Access Compliance Report Public Rights-of-Way (Curb Ramps)

Main Street: N_OCEAN_VIEW_ST		Cross Street: BIXBY_AVE		Location:	NW
ADA ID: RPAT210924123014	Ramp Type:Type 1 - Perpendicular	Initial Pass/Fail: Fail	Overall Compliance: No	Severity Score:	15

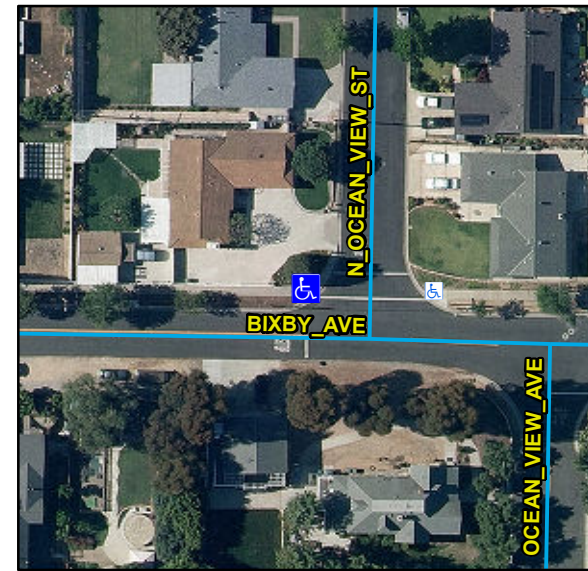
Remove & Replace Entire Ramp. Restripe Crosswalk.
